Prevost Car US (Inc) has determined that a defect which relates to motor vehicle safety exists in certain 2010 and 2011 models of X3-45 coaches, H3 series coaches and H3 VIP shells.

**SAFETY  
RECALL**

Sr11-10

DATE : MARCH 2011	SECTION : 03-FUEL
SUBJECT : REPLACEMENT OF THE FUEL TANK SUPPORT

APPLICATION OF SELF-ADHESIVE NEOPRENE FOAM (dark area)

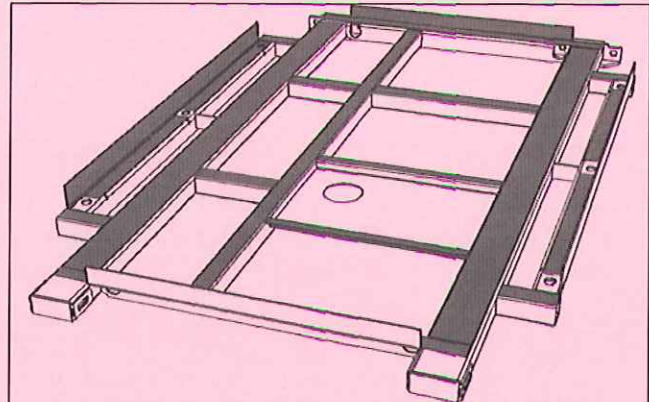
3. Apply self-adhesive neoprene foam (p/n 506758) on the new platform as shown.
4. Lift the vehicle.

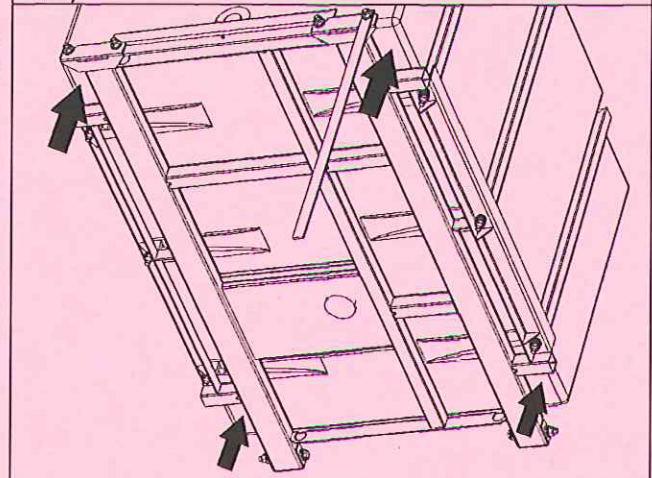
5. Using four jack stands, support the fuel tank at the four corners as indicated on the image.

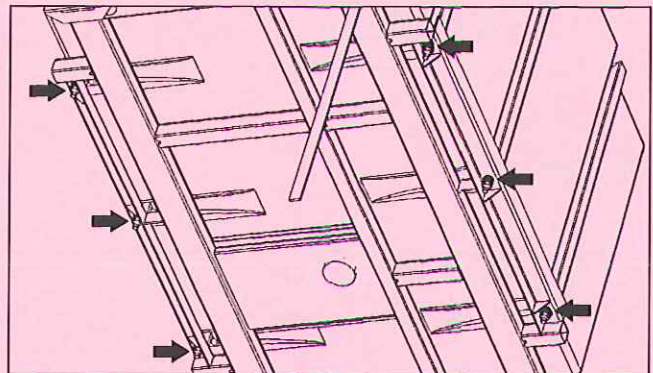
6. Unscrew the 6 tank retainer nuts.

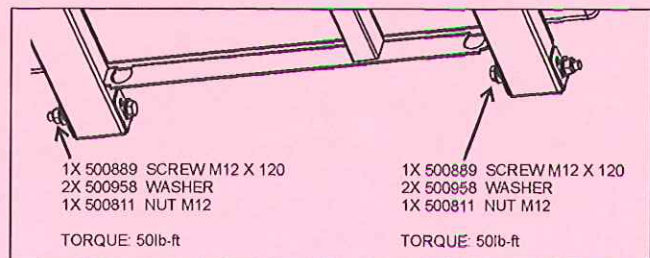
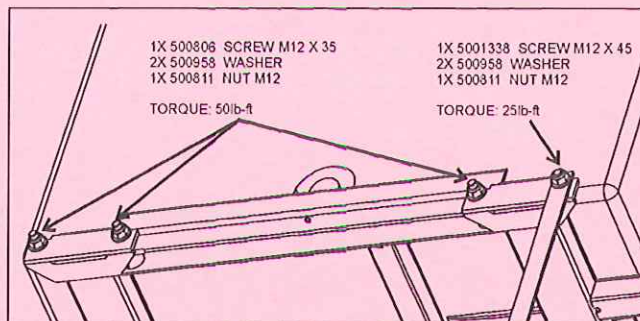
7. Unscrew the bolts (6) holding the fuel tank support to the vehicle chassis.
8. Replace the existing fuel tank support with the new one. Identify the defective support so it will not be reuse.
9. Install the new support with **new** hardware (bolts, washers and nuts).
  - Tighten bolts to 50 lb-ft (5 bolts)
  - Tighten bolts to 25 lb-ft (with static wick)

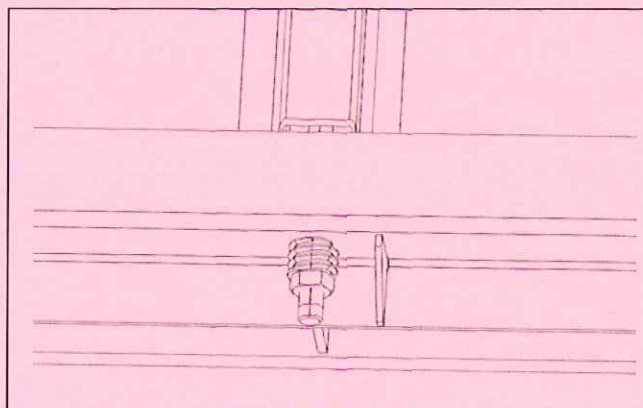
10. Thoroughly clean retainer studs to prevent mixing blue Loctite with anticorrosion compound. Reinstall fuel tank retainer nuts. Put blue Loctite on the retainer studs. Tighten nuts until springs are fully compressed and then loosen 3 complete turns.
11. Apply Valvoline anticorrosion compound or similar product on the bolts and nuts.
